Groundwater Transfer Review Summary Form

Transfer/PA # T- 14516

Application: T-14516

Applicant Name: Daniel & Leanne Miles

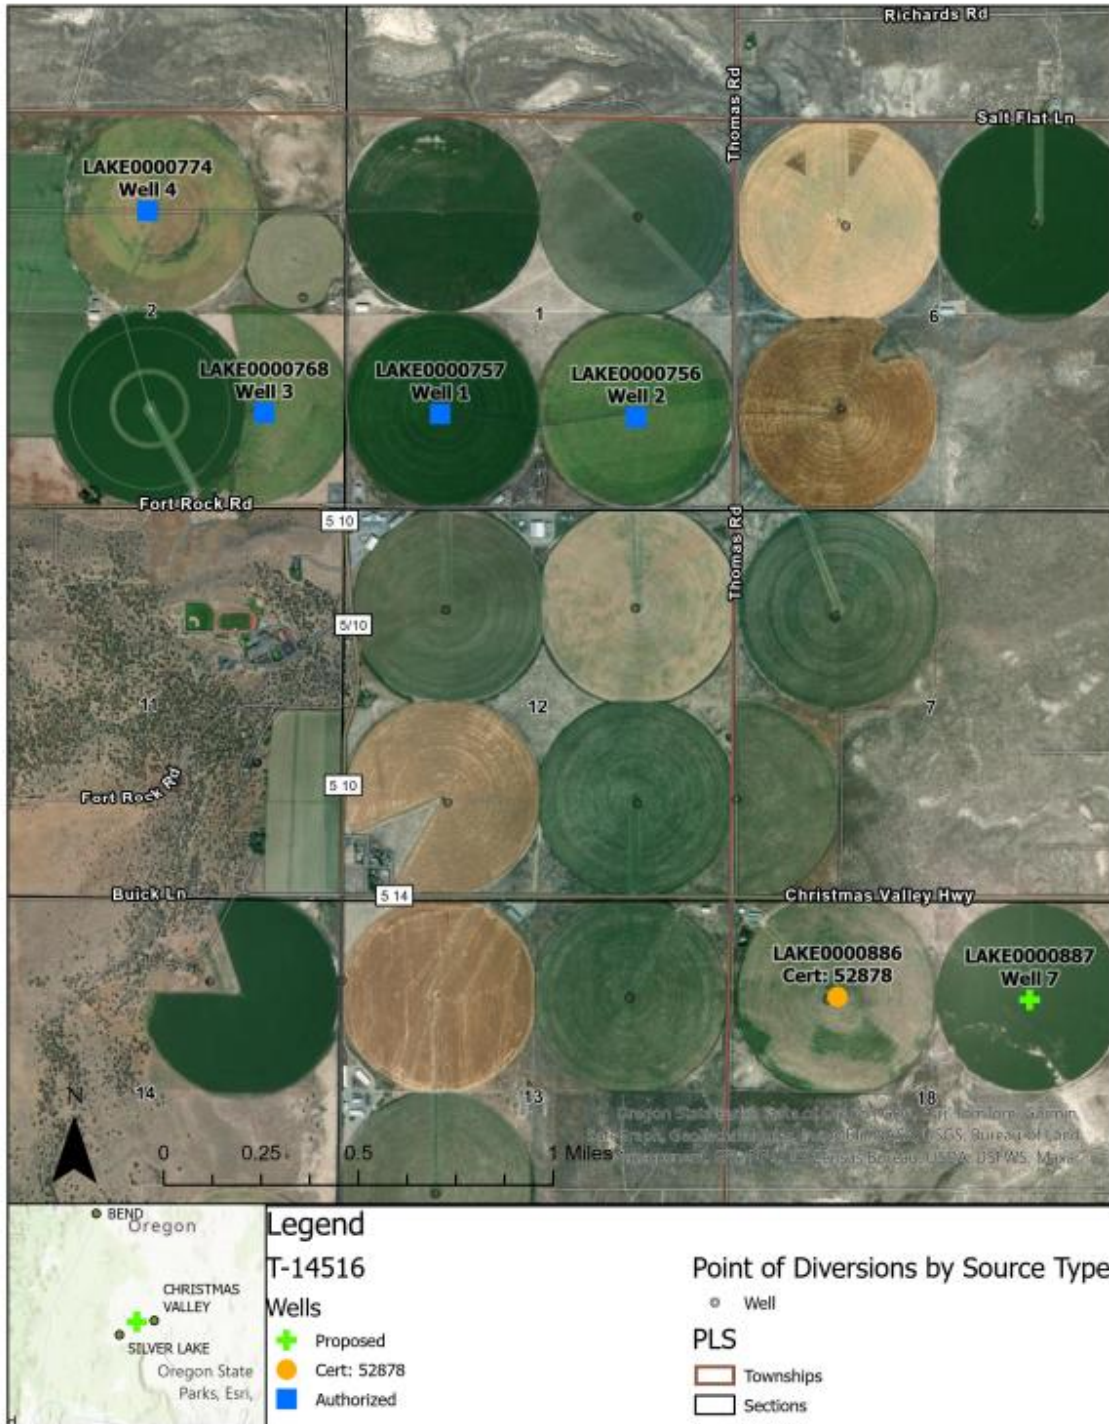
Yes No If yes, explain: The nearest authorized POA to Proposed POA LAKE 887 is LAKE 886 under Certificate 52878 which is located ~2,600 feet to the west. The potential increase in drawdown was calculated using the Theis equation (see attachments). The values used for the calculation are conservative and appropriate until better values become available. The calculation used an intermediate storage coefficient (0.001). The transmissivity used in the calculation (15,000 ft²/day) is from Morgan (1988) and McFarland and Ryals (1991). At the maximum allowed pumping rate on all water rights authorized on LAKE 887 (1.55 cfs), the results indicate a drawdown of ~5 feet, which would not meet the standard of “substantial or undue interference”.

Provide context for minimal/significant impact: Proposed POA LAKE 887 is located ~7.5 miles north of Silver Lake. While this is a reduction of distance when compared to the authorized POAs (~8.5 miles north), any increase in interference is expected to be minimal at that distance.
